REVISED RESPONSE TO REQUEST FOR ADDITIONAL INFORMATION

APR1400 Design Certification

Docket No. 52-046

RAI No.: 253-8300
SRP Section: 03.07.01 – Seismic Design Parameters
Application Section: 3.7.1
Date of RAI Issue: 10/19/2015

Figure 3.7A-14 Comparison of Design Time History Compatible with CSDRS with Site Response Motion at Foundation Base Elevation of Seismic Category I Structure, Vertical Motion, 5% damping

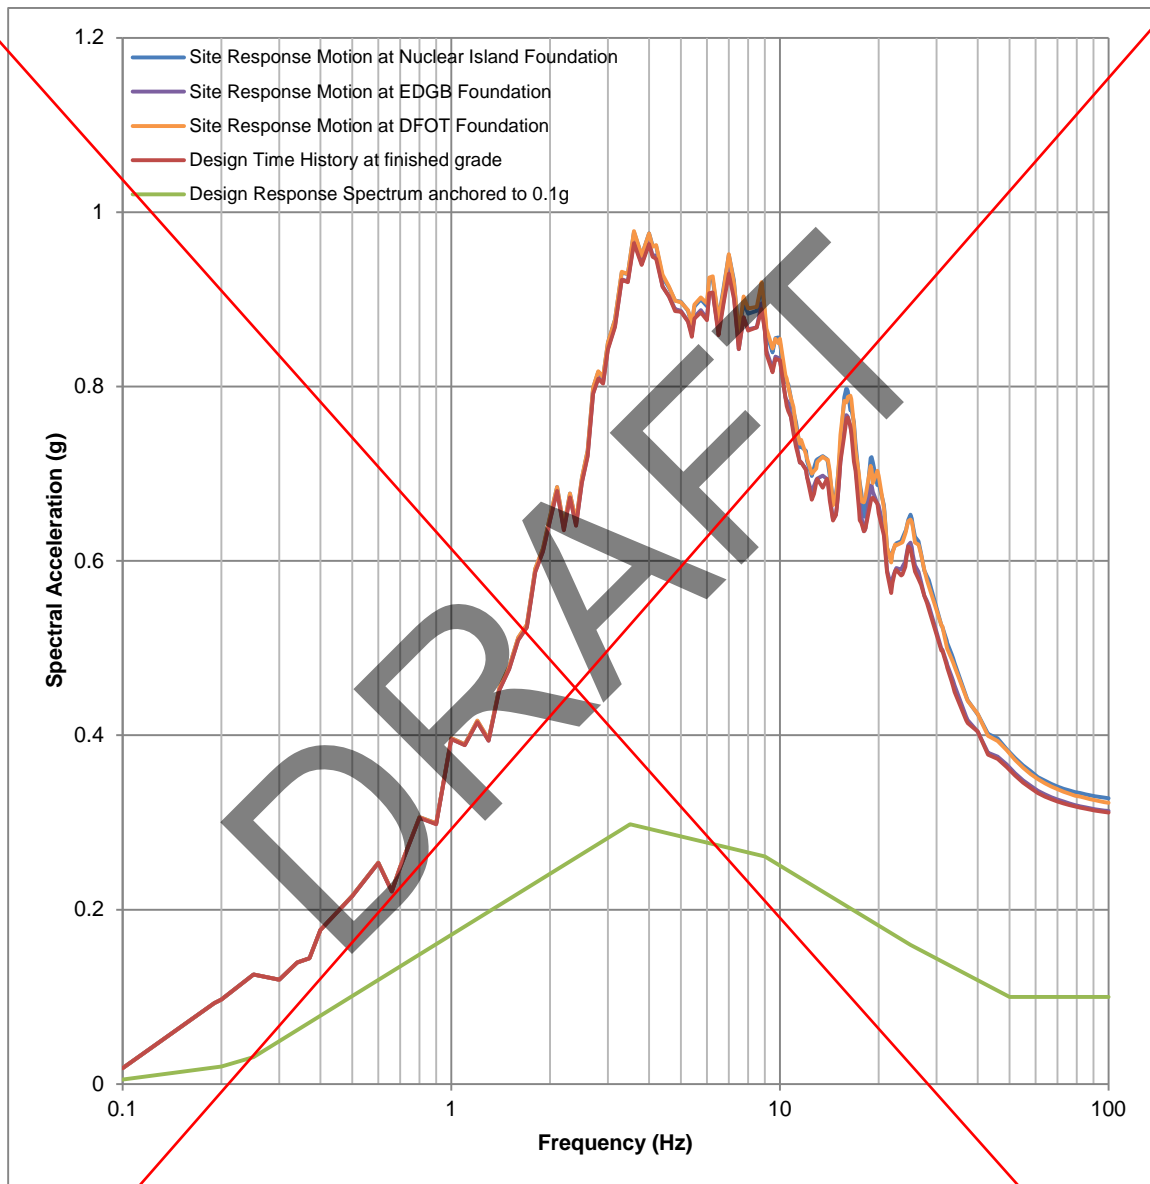
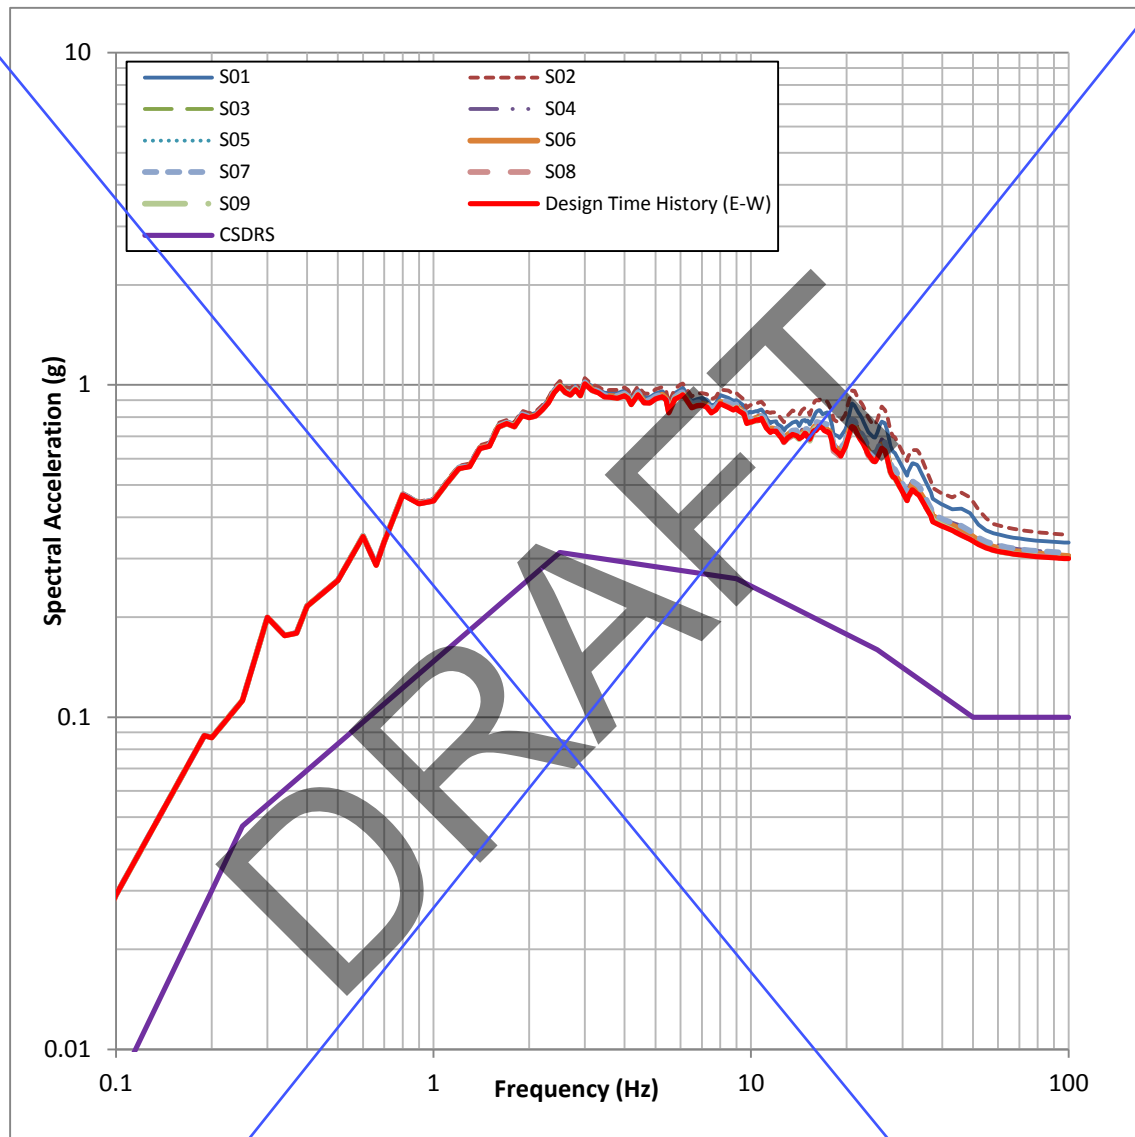
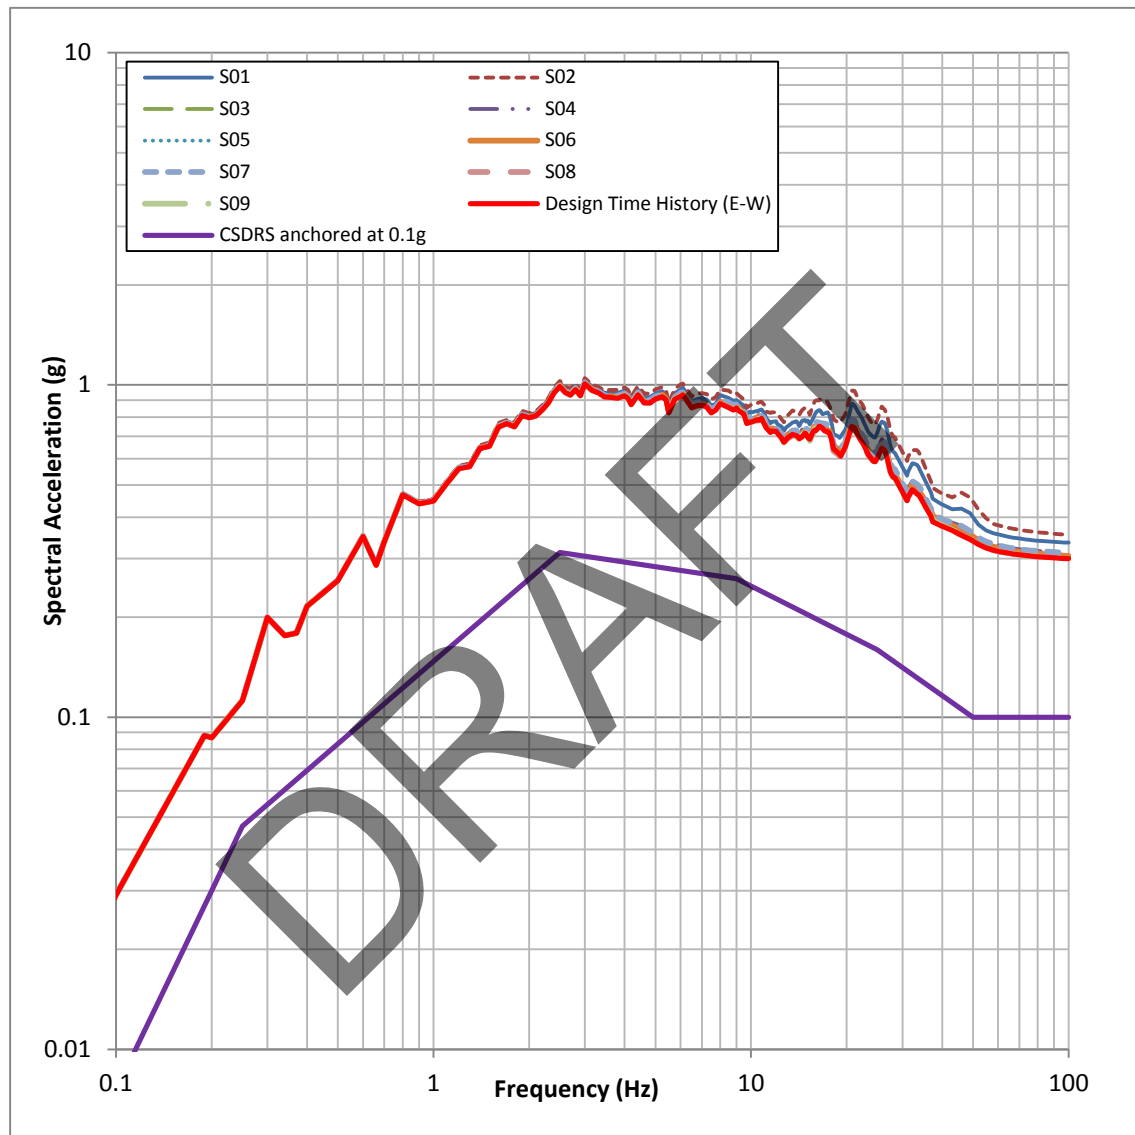
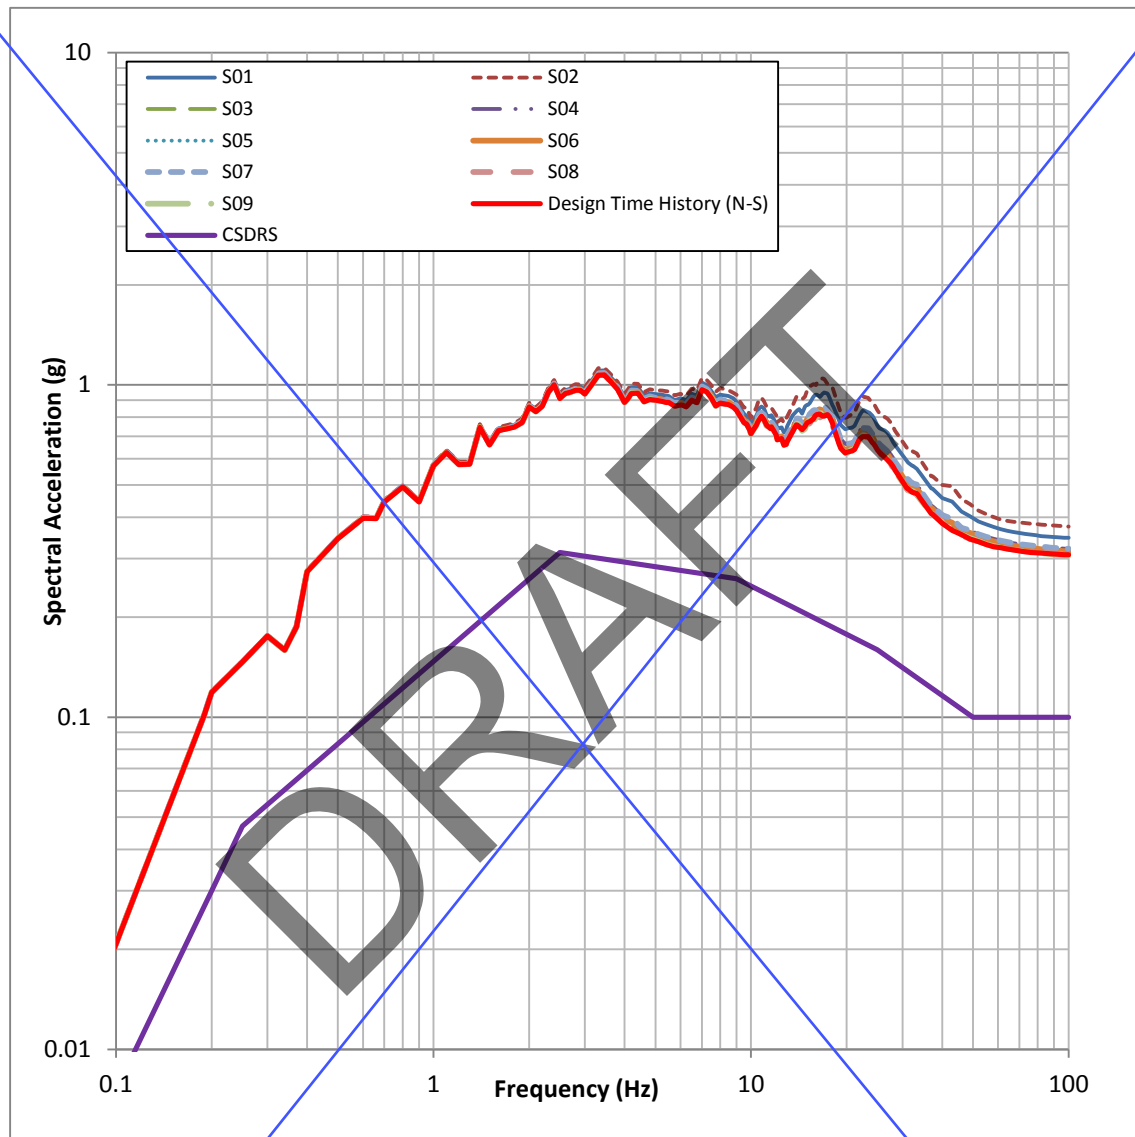
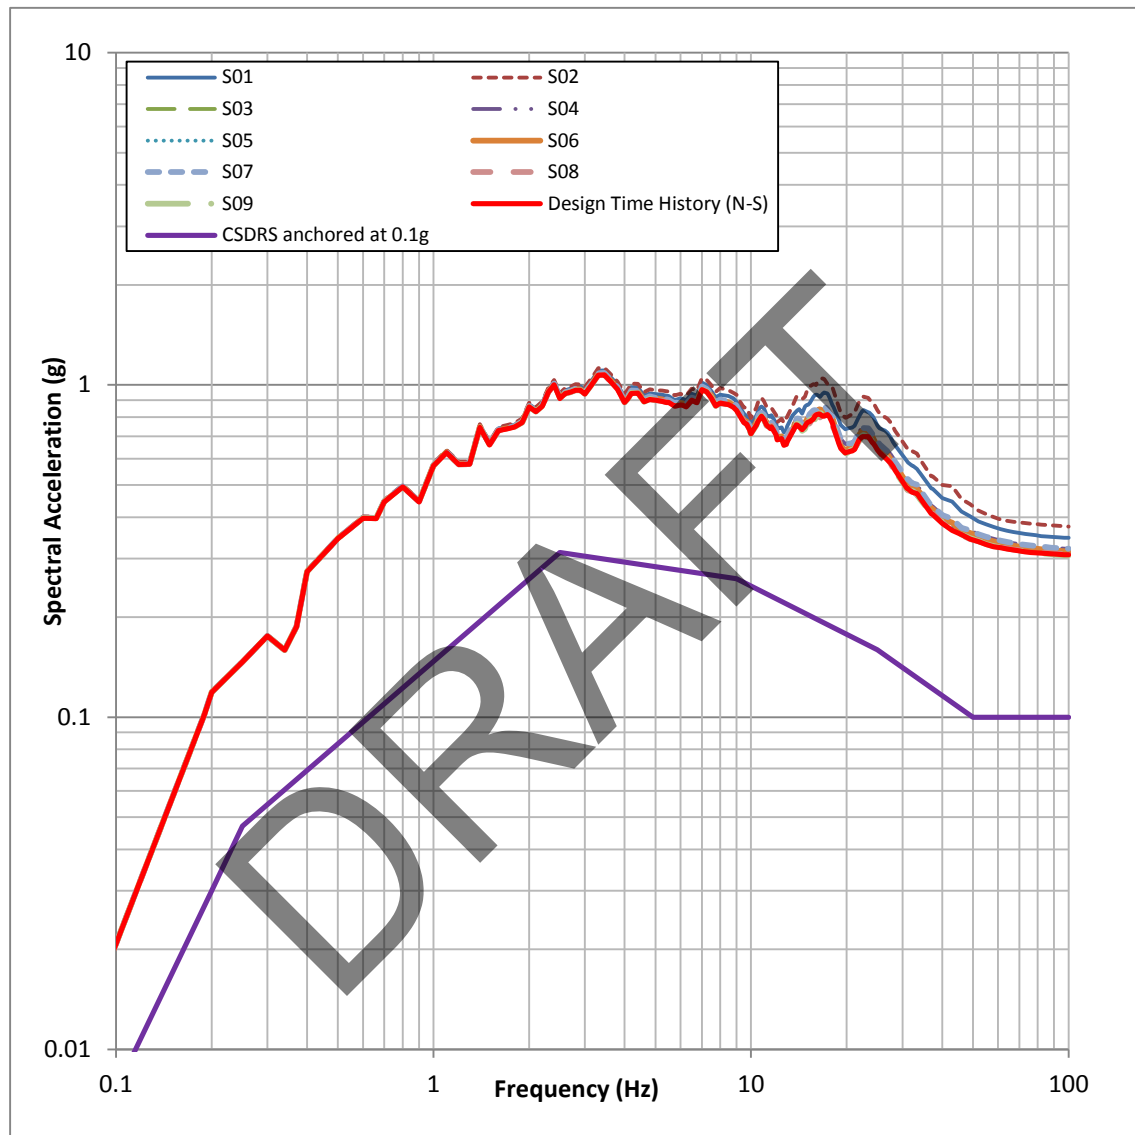
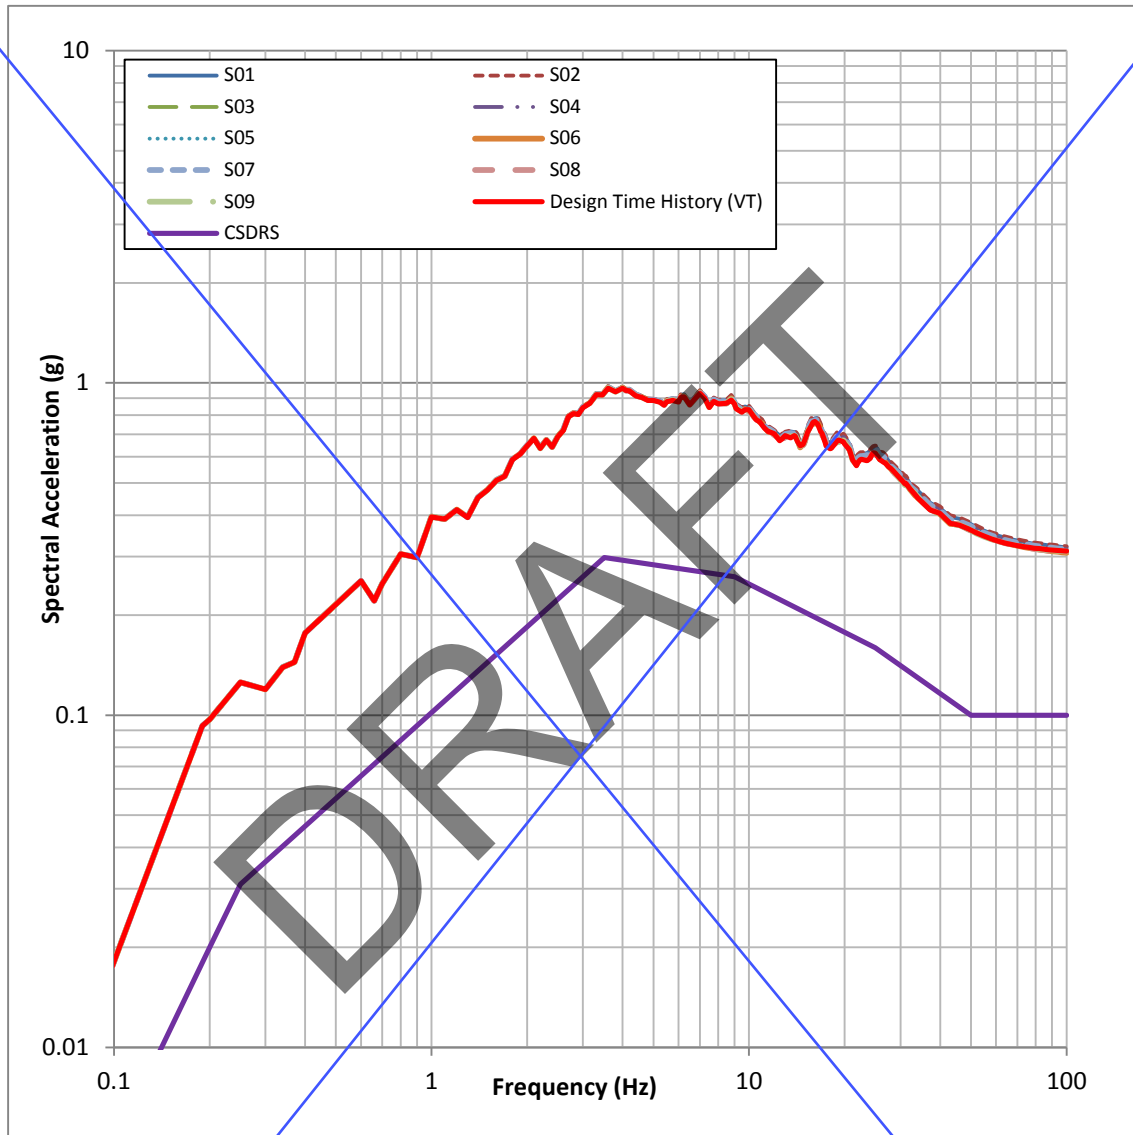
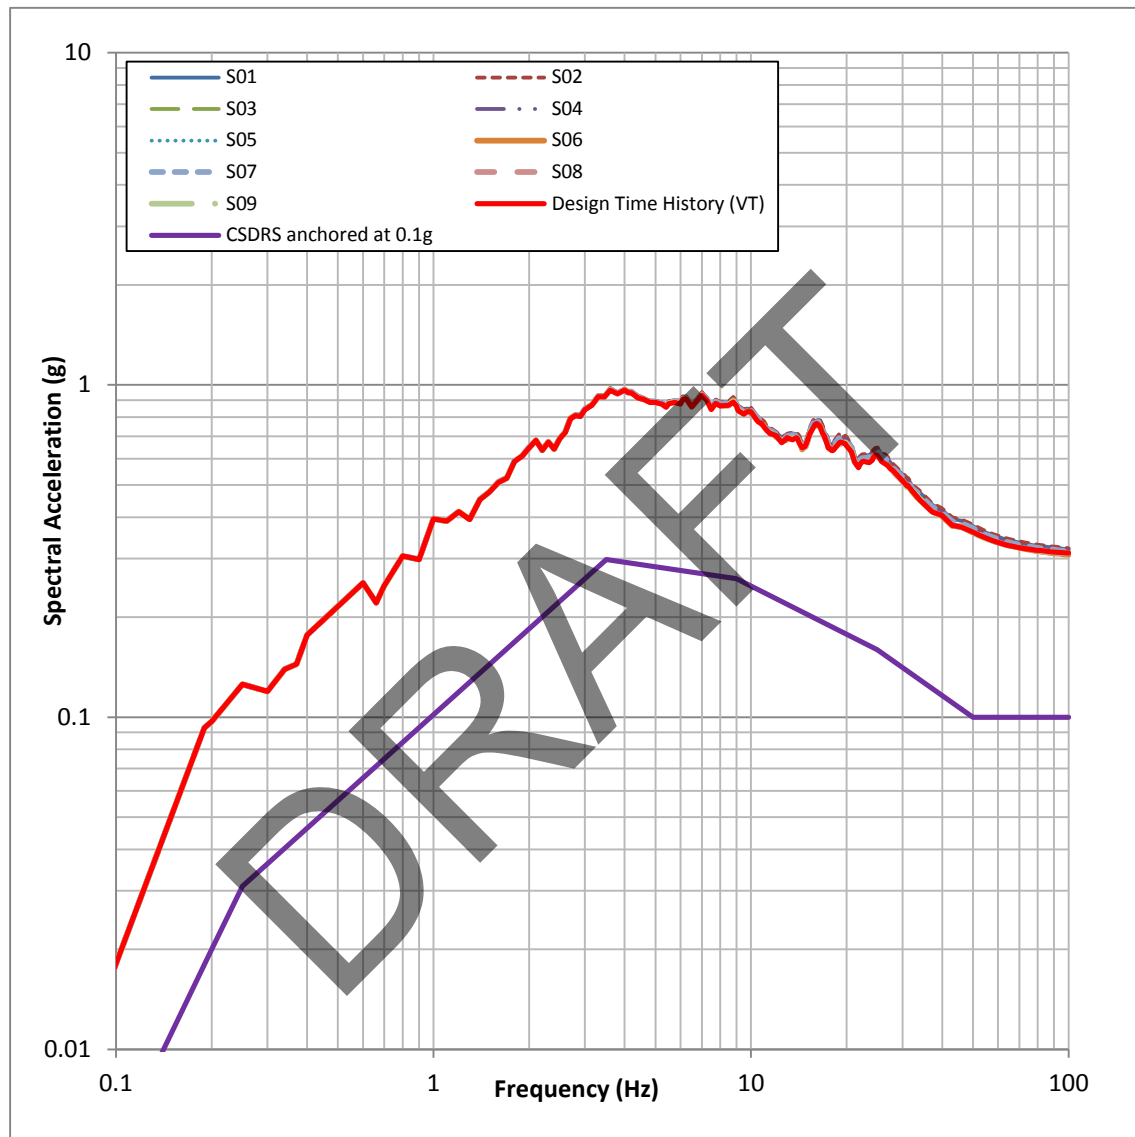
ii) The CSDRS are defined in DCD Section 3.7.1.1.1 as linearly interpolated on a log-log scale between the control points. The CSDRS scaled to 0.1g in Figures 3.7A-12, 3.7A-13, and 3.7A-14 are not correct because they are interpolated on a log-linear scale. Therefore, the CSDRS scaled to 0.1g should be corrected in Figures 3.7A-12 through 3.7A-14 of the DCD.

- a) Figures 3.7A-12, 3.7A-13, and 3.7A-14 in DCD Tier 2 and Figures 5-25 through 5-31 in APR1400-E-S-NR-14001-P/NP, Rev.0, "Seismic Design Bases" will be revised as indicated in the attachment associated with this response. The revised figures are presented on a log-log scale. Labels on the revised figures, along with those which have not been changed in the DCD and technical reports, have been reviewed and confirmed to be correct. DCD Tier 2, Section 3.7.6 cites ARP1400-E-S-NR-14001-P/NP, Rev.0, "Seismic Design Bases" as Reference 9.
- b) The $CSDRS_{ff}$ is generated from outcrop motions using the SHAKE91 program. The outcrop motions are calculated at the foundation elevation of each building. The procedure described in the NEI white paper, "Consistent Site-Response/Soil-Structure Interaction Analysis and Evaluation," (June 12, 2009) was followed to produce the results.
